RE: US 181 Harbor Bridge Replacement Project
CSJ No.: 0101-06-095
FDLLC Response to TxDOT Notice of Developer Default – Proposed Schedule of Design
Modifications and Action Plan

Flatiron Dragados LLC
**US181 Harbor Bridge
Replacement Project**
Proposed Action Plan

277609-NHB-REP-Action Plan

02 | August 30, 2022

Figure 1 | Layout of additional drilled shafts

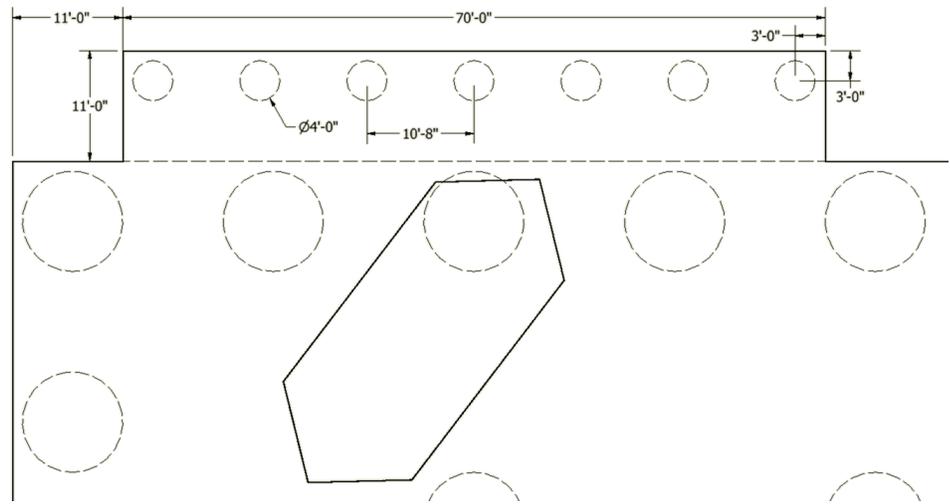
Figure A5 1NT of IBT’s TM 1001 was used as a basis for determining an additional drilled shaft arrangement that it is considered will be acceptable to TxDOT based upon the design criteria and demands presented by IBT. For the North Tower, a total of seven additional drilled shafts are proposed in a line along each long edge of the footing in the vicinity of the tower leg.

Figure 2: Section through footing extension

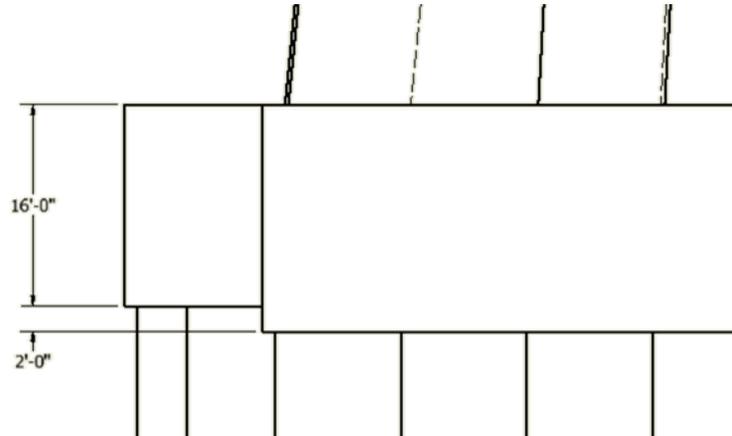
An extension to the footing will be provided. This will be attached by bars which are drilled and fixed into the existing footing.

The placement of these bars is critical to avoid damage to the existing reinforcement. The following measures may be taken:

- The interface will be prepared to the specified roughness and the side bars will be located and mapped.
- The existing shear reinforcement (on a 2ft x 2ft grid) will be mapped and all drill and fix bars will be centrally located in the gaps between these bars.
- The main tension steel (bottom) will be located above the bottom mat of the existing footing and will only be installed in the gaps between the drilled shafts so that there are no conflicts with the projecting shaft reinforcement
- The shear friction reinforcement will be curtailed as necessary to avoid conflicts with the tower leg dowel bars.

Figure 4 | Plaxis model of modified foundation (NT1)

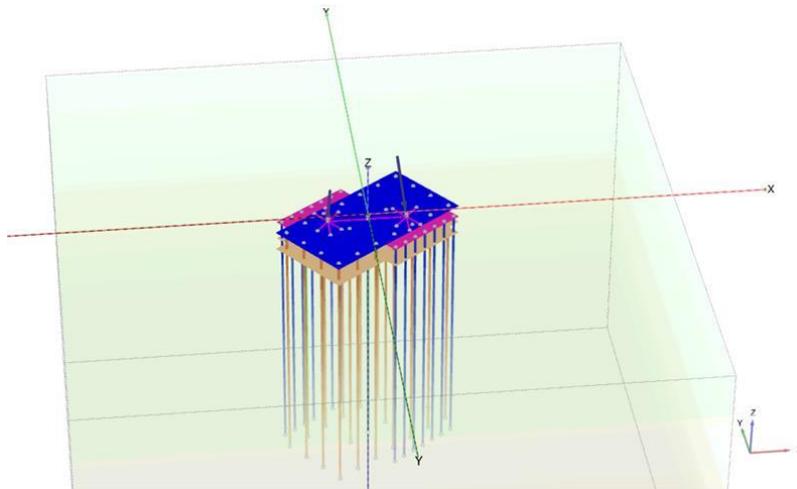
A preliminary Plaxis analysis of this modified foundation has been carried out for tower NT1 with input loads taken as the 270 degree wind load combination tower leg loads provided by IBT with an operational importance factor of 1.05. This produces the largest reported demand / capacity ratio in IBT TM 1001. The analysis models the flexibility of the footing and non-linear response of the ground.

The analysis includes consideration of staged construction. Loads representing the current state of construction are first applied to the current foundation and then the additional foundation elements are activated. Finally, the additional loads to reach the loads in IBT TM 1001 are applied.

Figure 5: Deformed shape of the footing (1NT 270 deg. IBT input loads, OIF = 1.05)

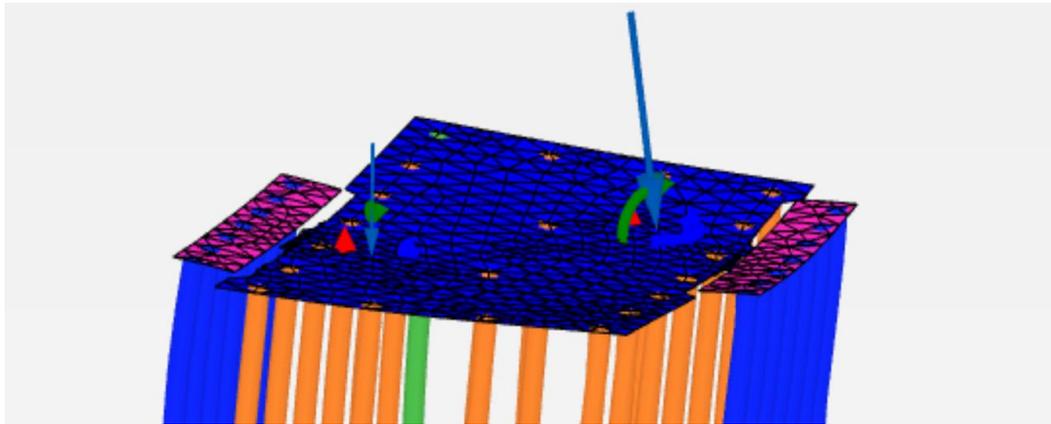
The deformed shape of the footing is shown in Figure 5. Drilled shaft loads and displacements are shown in Figure 6 and Figure 7 respectively. All shaft loads are less than the factored capacity and all shaft displacements are less than 5% of shaft diameter.

Figure 10 | Critical perimeters for two way action based on IBT Technical Memorandum

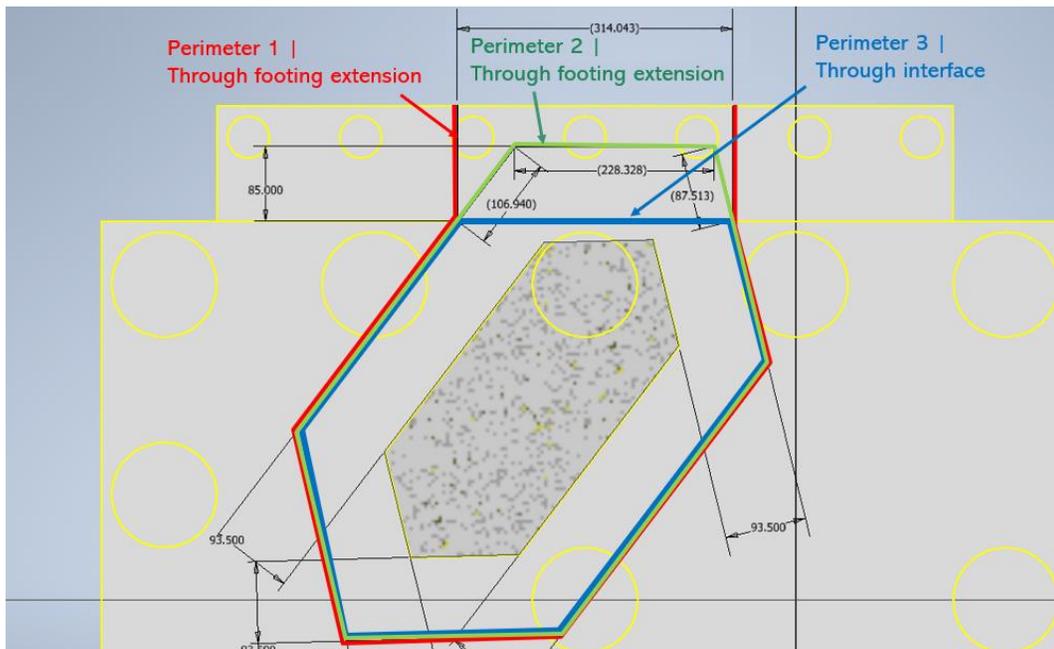
Figure 10 shows three perimeters for two way shear action for the modified foundation. Note that these perimeters were determined by extending the critical perimeter shown by IBT in Appendix A3 of TM 1002.

The tower footing extension will be 5.5 ksi concrete and will be provided with six legs of #11 shear reinforcement at 12” centers which will be sufficient to achieve the maximum resistance allowed by AASHTO LRFD Eq. 5.13.3.6.3-2. The factored shear resistance of the footing extension will be approximately 8,700 kips and 2.75 additional drilled shafts are contained within Perimeter 1.

The interface between the footing and the footing extension will be designed with a factored interface shear capacity of at least 28,000 kips over the region shown in Figure 10 so that Perimeter 3 adds at least 28,000 kips to the capacity. As such:

- The footing extension provides at least an additional 28,000 kips of capacity which is more than the shortfall calculated by IBT in Appendix B3 of TM 1002.
- The 28,000 kips of additional capacity is approximately 25% of the maximum leg load. Therefore, the leg is supported on all four sides and IBT's concerns over the proximity of the leg to the edge of the cap are addressed.

Figure 11. Proposed reinforcement layout. New reinforcement shown in red, all other reinforcement is existing.

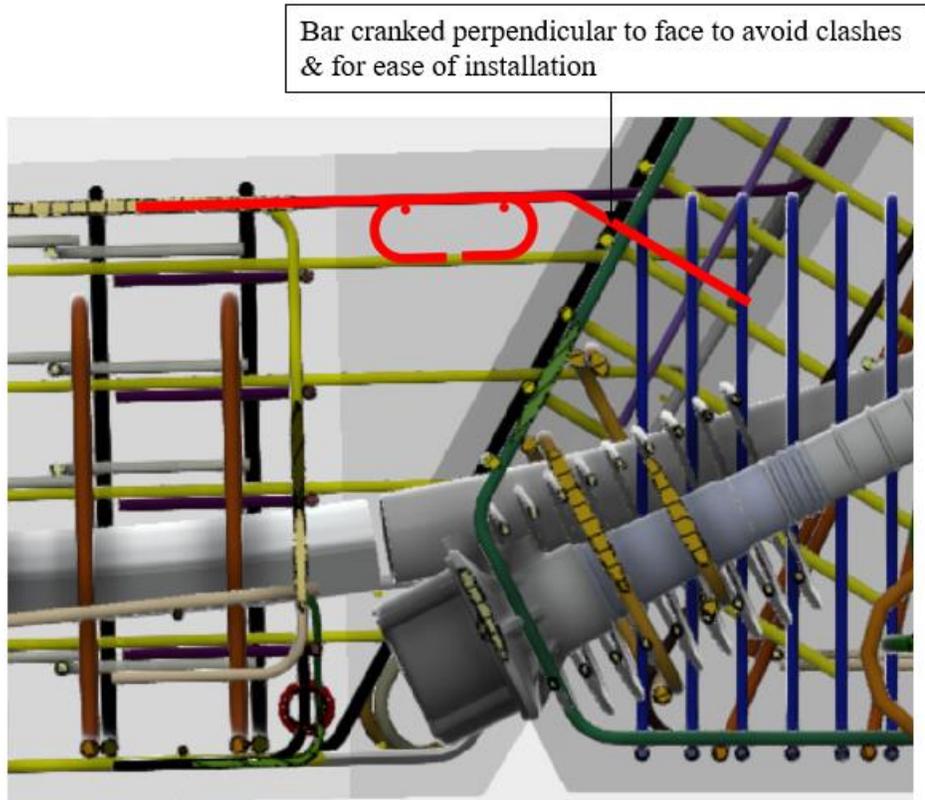
We propose to provide (8) eight #4 bars in the transverse direction (across the joint) and (2) two #4 bars in the longitudinal (secondary) direction.

The transverse reinforcement will be cranked in the delta frame end to run parallel to the existing reinforcement and avoid clashes as shown in Figure 11. The existing bars will be located and mapped prior to drilling to avoid clashes.

The transverse reinforcement would be drilled and epoxied into the precast segment and delta frame on either side of the cast-in-place (CIP) joint. A minimum embedment length of 12" (tension development length for #4 bar to AASHTO LRFD 5.11.2) will be provided. The reinforcement will overlap and terminate within the CIP joint with a standard hook following the detailing requirements of AASHTO LRFD Figure C5.11.2.4-1.

Figure 12. Proposed reinforcement installation sequence

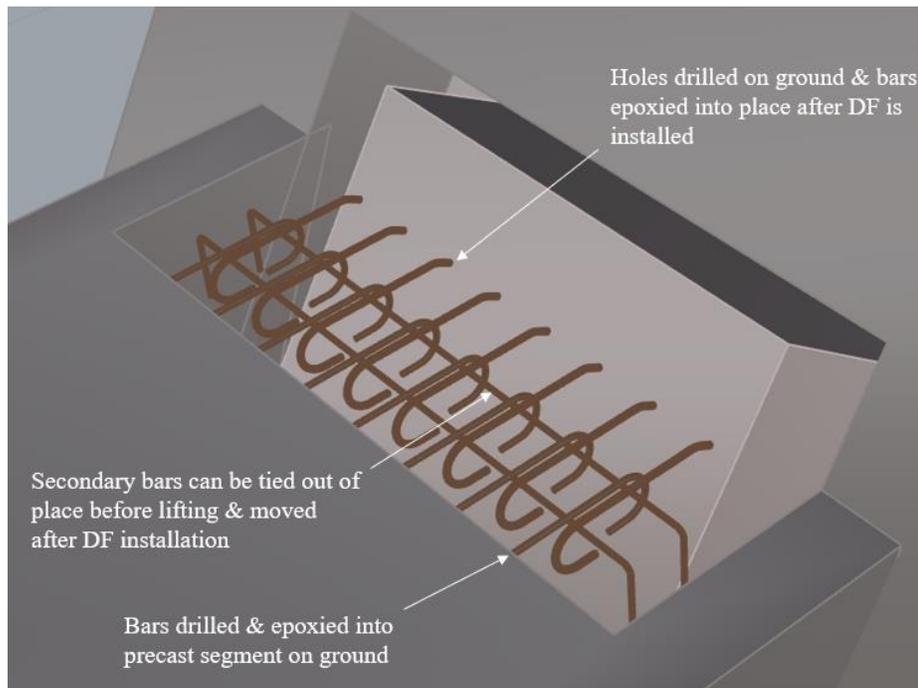
Figure 12 shows how the proposed reinforcement arrangement would be installed to ensure ease of constructability. The bars which are continuous into the precast box girder segment would be drilled and fixed on the ground. The bars which are continuous into the delta frame would be epoxied into predrilled holes after the delta frame is in position. The secondary bars would be tied out of place and then moved into position after the delta frame is installed.

Figure 14 | Modifications will be required to the already built transition pier diaphragm

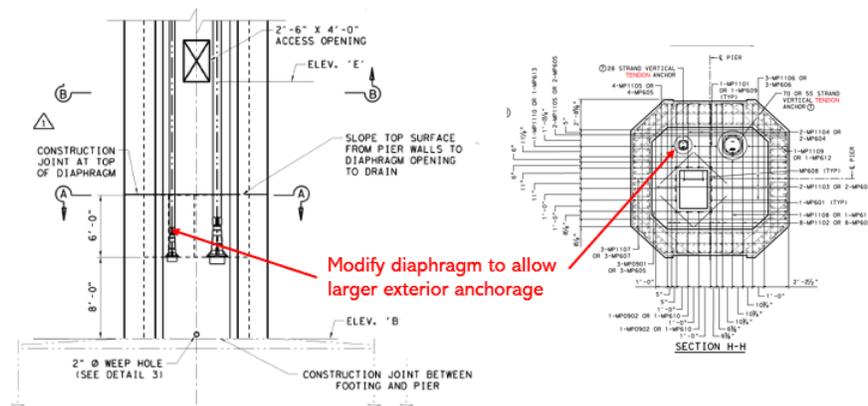
Modifications will be required to the transition pier diaphragm which has already been built. This will require partial demolition, reinforcement adjustment and pour back of new concrete in a relatively confined space. We have reviewed the DSI shop drawings for the hold downs and the slot in the pier cap may also need to be enlarged.

Proposed Design Modification Tower Footing

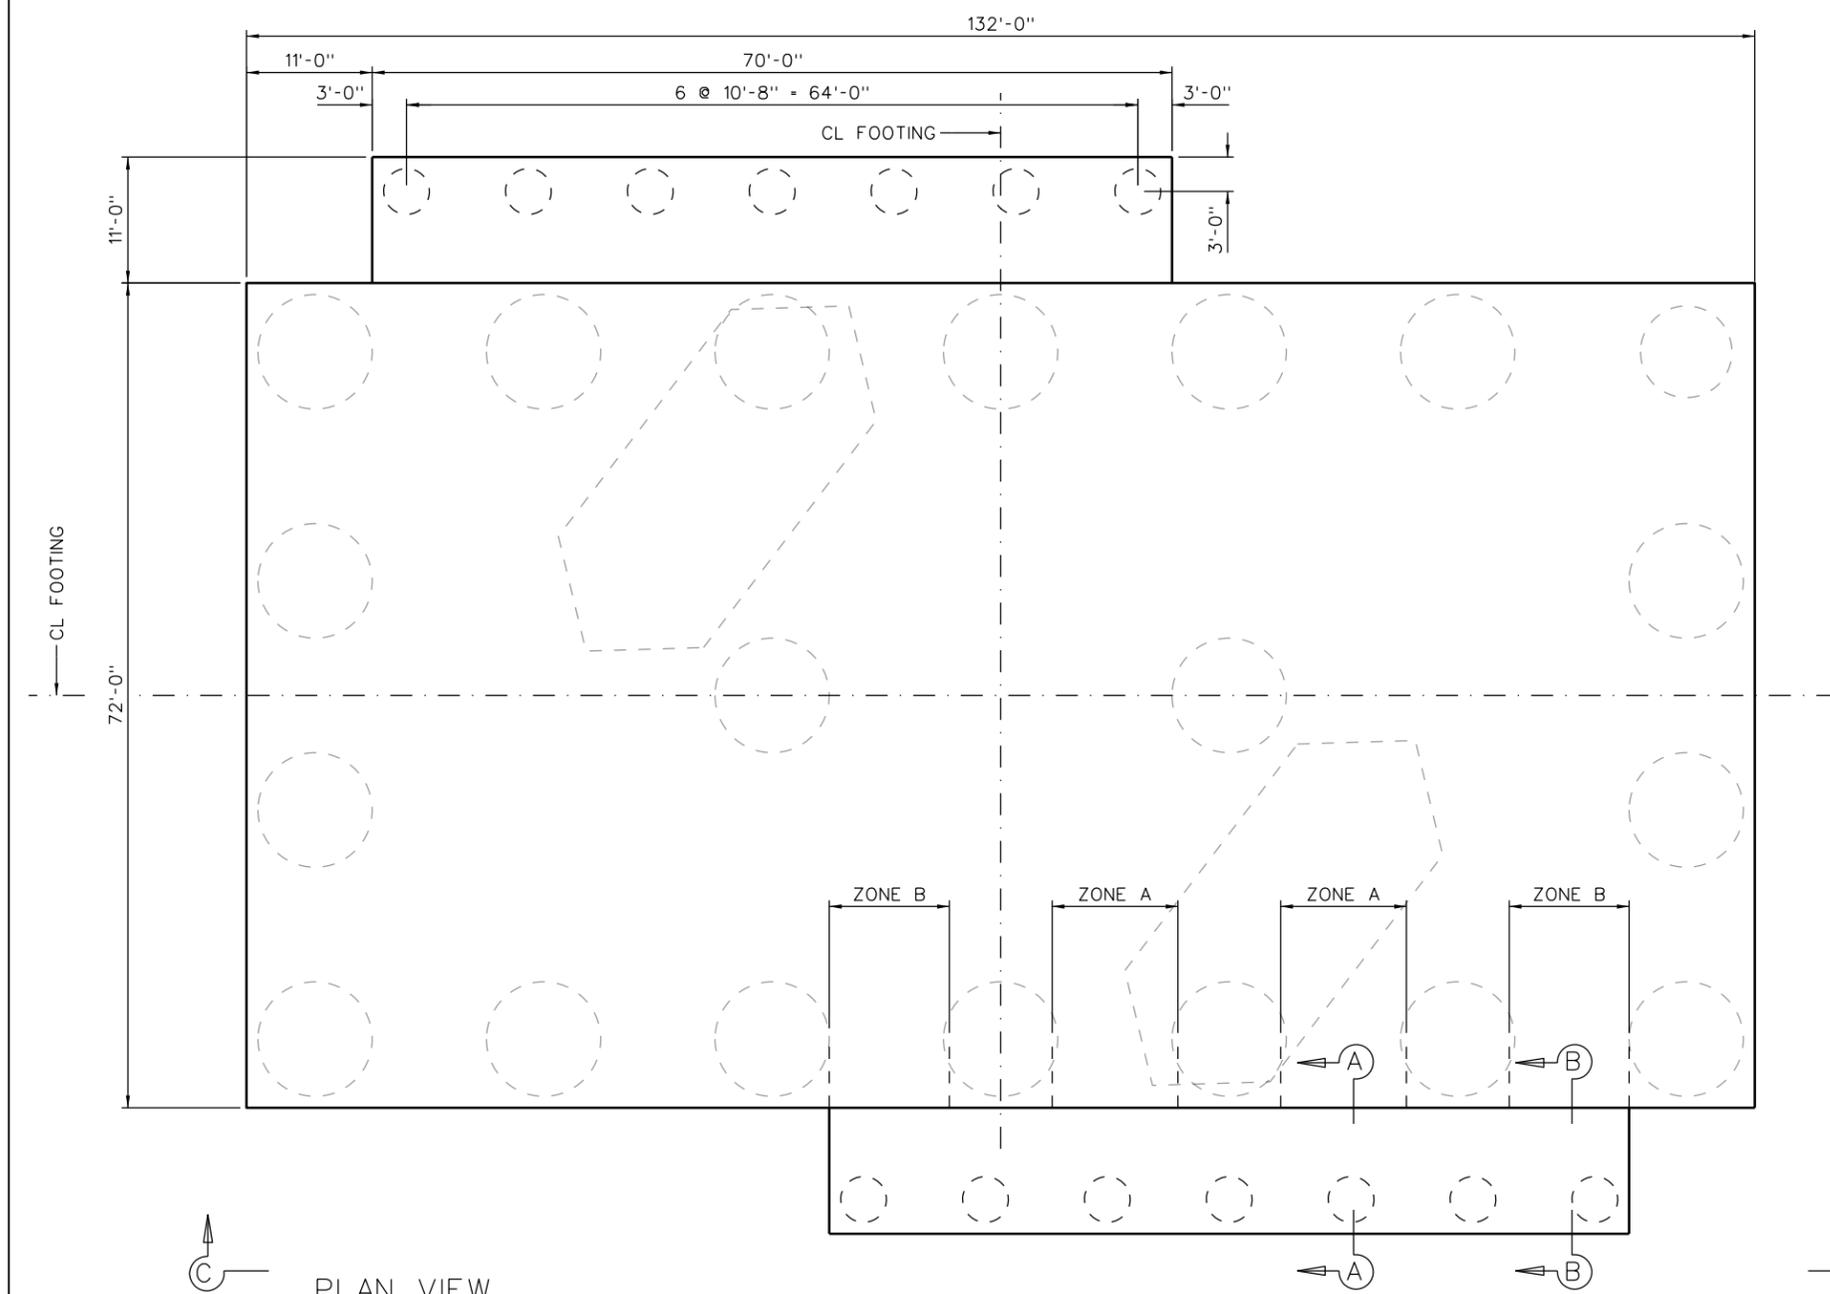
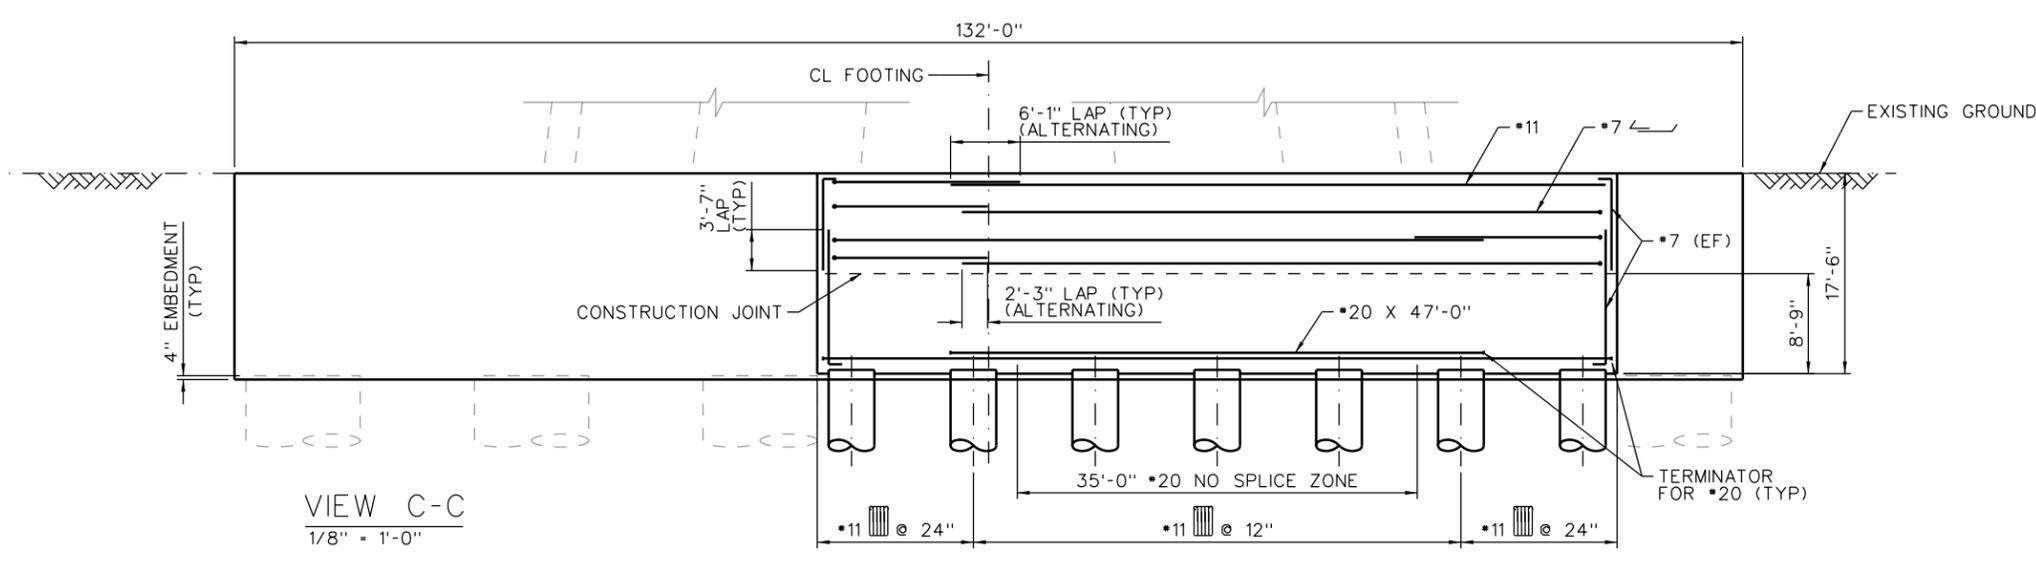
Appendix A of this report includes a preliminary drawing of this proposed design modification for the North Tower. The South Tower will be similar but with a reduced extension and reduced number of piles.

- NOTES:
1. ALL DETAILS SHOWN ARE PRELIMINARY AND SUBJECT TO DEVELOPMENT.
 2. EXTENSION TO FOOTING SHALL BE 5.5 KSI CONCRETE.
 3. LENGTH OF 4FT DIAMETER DRILLED SHAFTS SHALL BE SIMILAR TO EXISTING DRILLED SHAFTS.

US-181 HARBOR BRIDGE
MAIN SPAN
TOWER 1NT & 1ST
FOOTING EXTENSION II

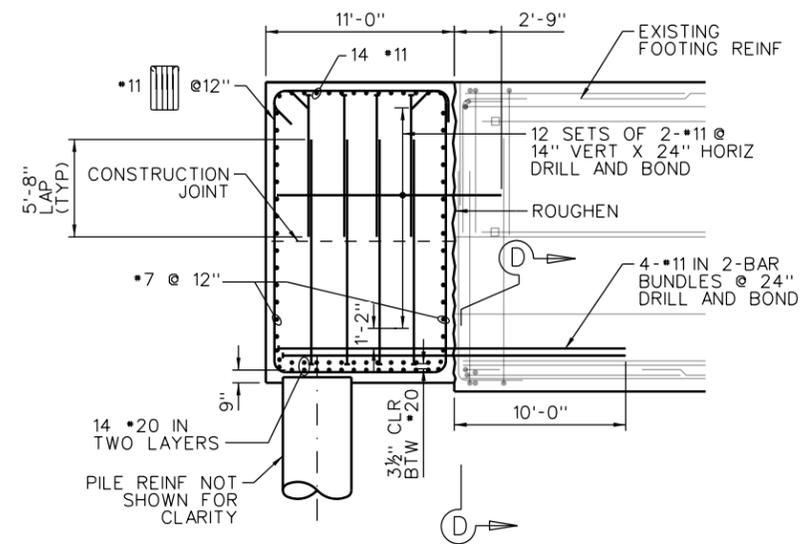
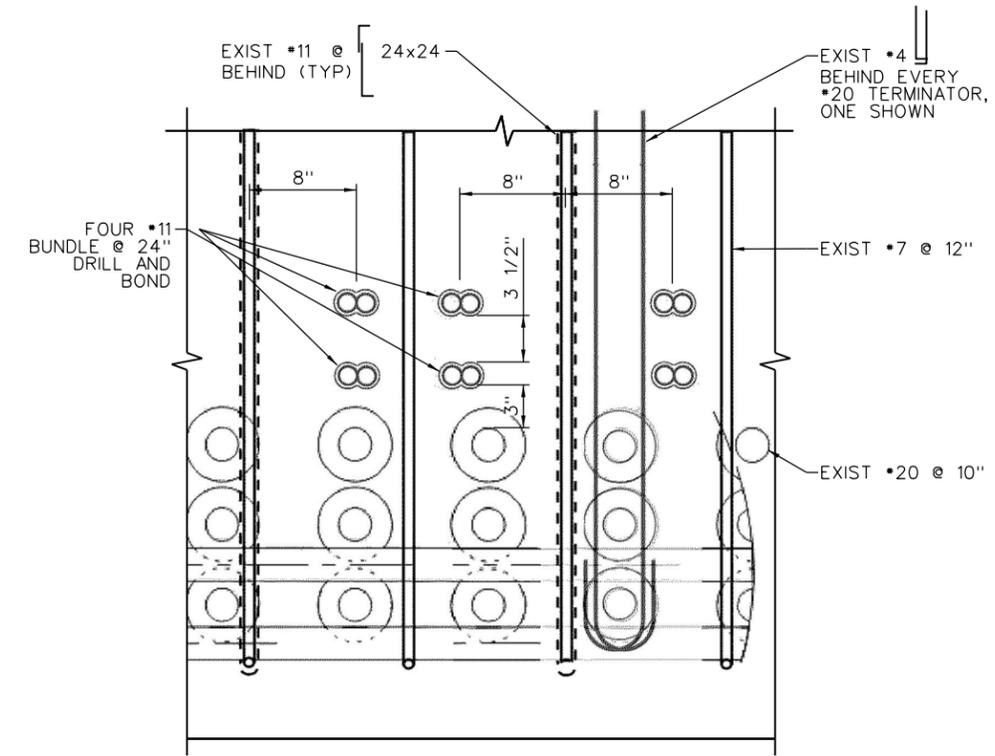
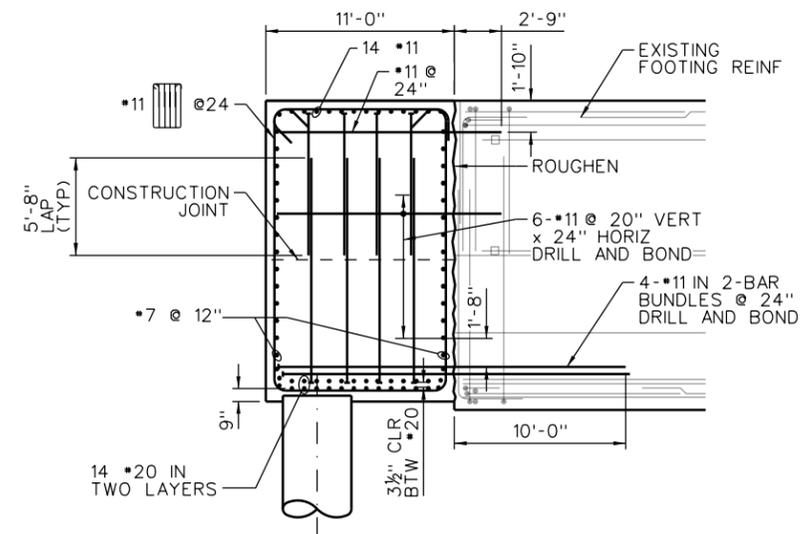
- NOTES:
1. INTERFACE BETWEEN FOOTING AND EXTENSION SHALL BE INTENTIONALLY ROUGHENED TO 1/4" MINIMUM AMPLITUDE.
 2. LOCATION OF SIDE REINFORCEMENT SHALL BE IDENTIFIED BY COVER METER SURVEY OR REMOVAL OF COVER.
 3. LOCATION OF SHEAR REINFORCEMENT IN EXISTING FOOTING SHALL BE IDENTIFIED AND MAPPED PRIOR TO INSTALLATION OF ANY DRILL AND BOND BARS. ALL DRILL AND BOND BARS SHALL BE IN THE APPROXIMATE CENTER BETWEEN MAPPED LINES OF SHEAR REINFORCEMENT. ADJUSTMENT BASED ON AS-BUILT LOCATION OF VERTICAL REINFORCEMENT TO BE COORDINATED WITH EOR.
 4. BARS WILL BE STOPPED SHORT OR OMITTED WHERE THEY WOULD OTHERWISE CLASH WITH THE TOWER DOWEL BARS.
 5. #20 BAR DESIGNATIONS ARE WILLIAMS GRADE 75 THREADBAR. THEY SHALL BE SPLICED WITH COUPLERS CAPABLE OF RESISTING 125% OF THE BAR YIELD STRENGTH.
 6. REINFORCEMENT FROM DRILLED SHAFT INTO FOOTING NOT SHOWN FOR CLARITY.
